POINT BEACH NUCLEAR PLANT, UNIT NO. 1

AMENDMENT TO FACILITY OPERATING LICENSE

Amendment No. 36  
License No. DPR-24

ATTACHMENT TO LICENSE AMENDMENT NO. 36  
CHANGES TO THE TECHNICAL SPECIFICATIONS  
FACILITY OPERATING LICENSE NO. DPR-24  
DOCKET NO. 50-266

FIGURE 15.3.1-1

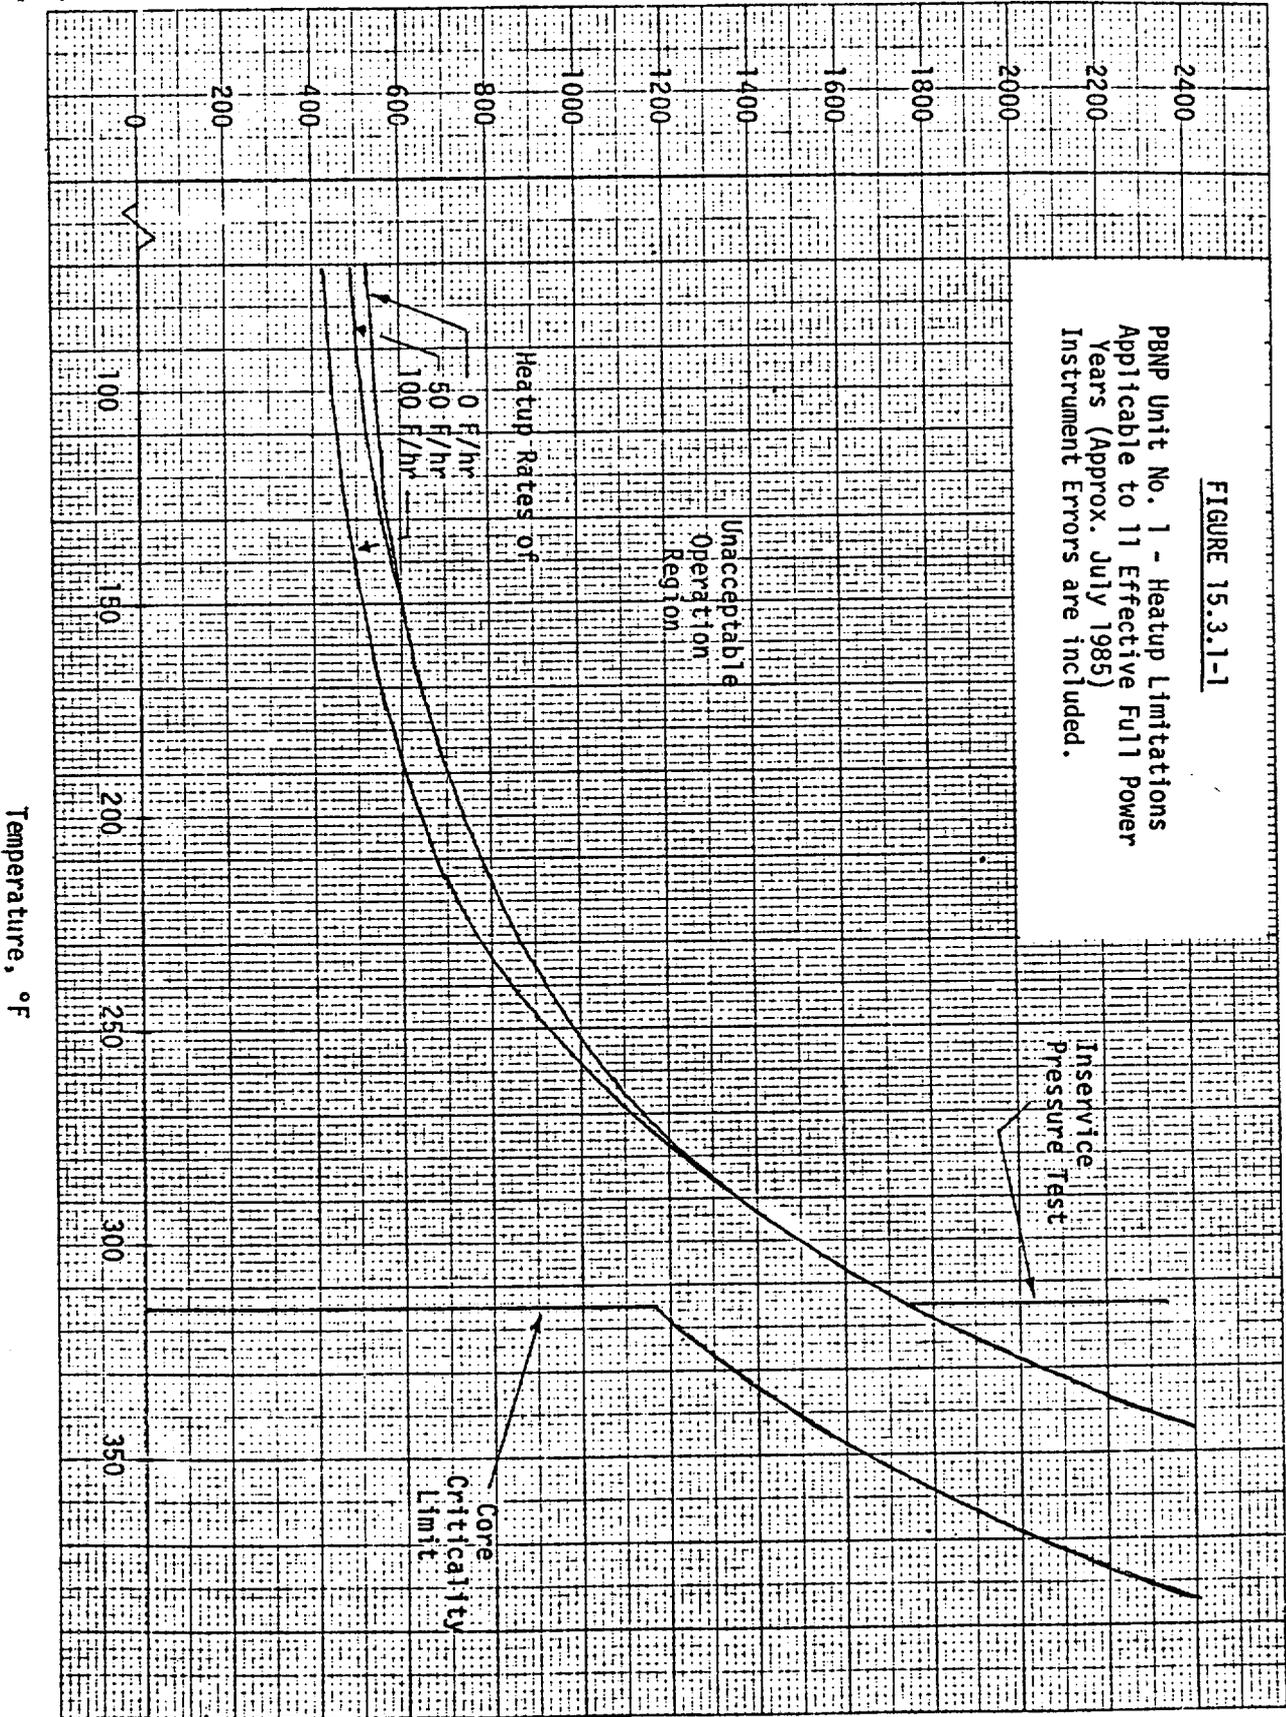
1. Remove Table 15.3.1-2 and Figures 15.3.1-3 and 15.3.1-4 (no replacements).
2. Remove Figures 15.3.1-1 and 15.3.1-2 and replace with revised figures bearing the same numbers.

PBNP Unit No. 1 - Heatup Limitations  
Applicable to 11 Effective Full Power  
Years (Approx. July 1985)  
Instrument Errors are included.

The revised operating limits are based on the data and calculation methods contained in Westinghouse Report WCAP-8743.<sup>2</sup> The licensee has requested that the period of applicability of the present operating limit curves in the Technical Specifications be extended from seven to eleven effective full-power years (EFPY) for Unit 1. Point Beach Unit No. 1 will reach seven EFPY in about June 1980.

first two capsules removed from the vessel indicated that the Charpy upper shelf energy might fall below 50 ft-lbs at about seven EFPY. Therefore, in a previous evaluation of Point Beach 1 operating limits, the staff limited their applicability to seven EFPY. However, the results from the third capsule, removed from the vessel in 1977, indicate that the upper shelf energy is not decreasing as rapidly as previously thought. We now conclude that at 11 EFPY the upper shelf energy will be above 50 ft-lbs.

The proposed limits will be in accordance with Appendix G, 10 CFR 50 through eleven EFPY. Conformance with Appendix G to 10 CFR Part 50 in establishing safe operating limitations will ensure adequate safety margins during operation, testing, maintenance and postulated accident conditions and constitutes an acceptable basis for satisfying the requirements to NRC General Design Criterion 31, Appendix A, 10 CFR Part 50. From our review we conclude that the proposed pressure-temperature operating limits for Point Beach Unit No. 1 are acceptable for operation through eleven EFPY.

FIGURE 15.3.1-2

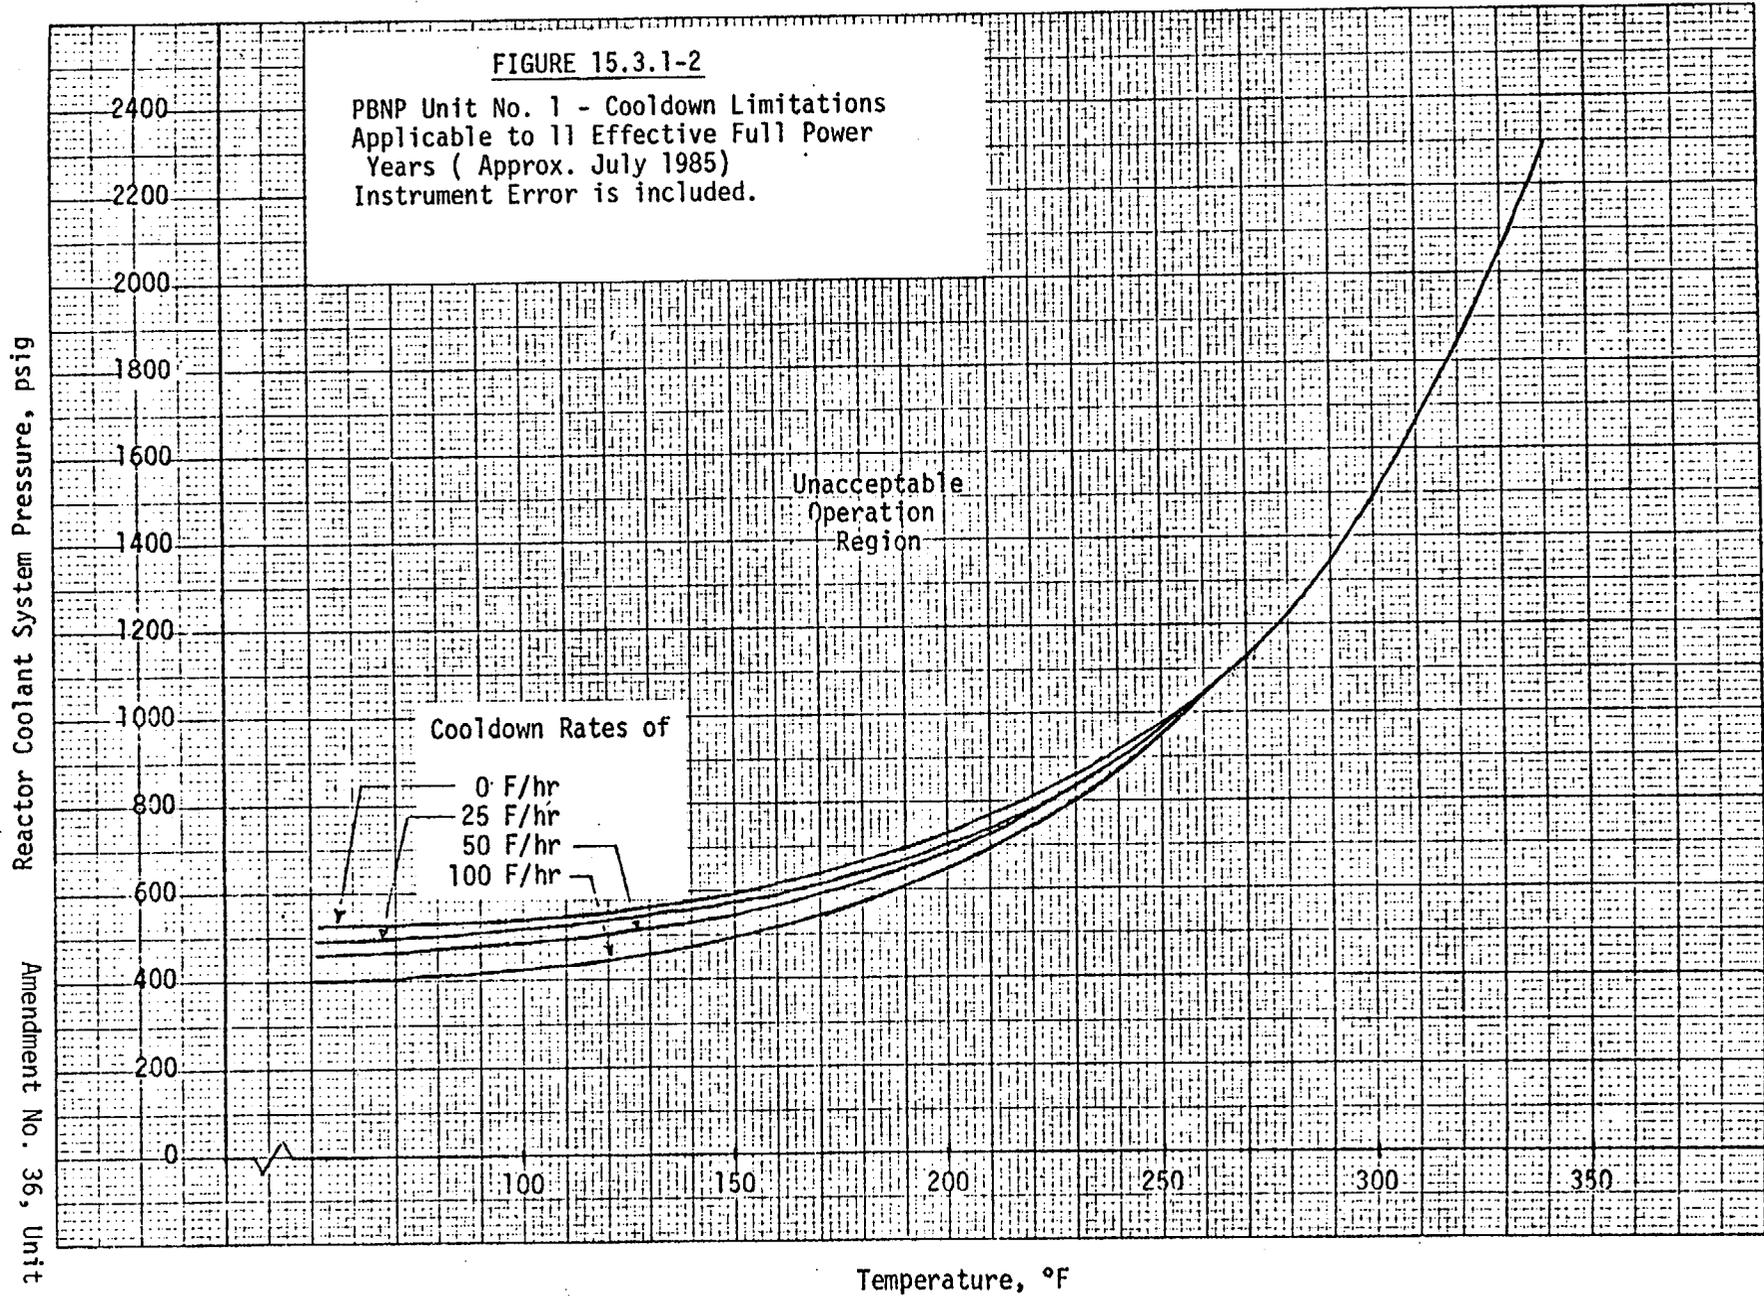
PBNP Unit No. 1 - Cooldown Limitations  
Applicable to 11 Effective Full Power  
Years ( Approx. July 1985)  
Instrument Error is included.
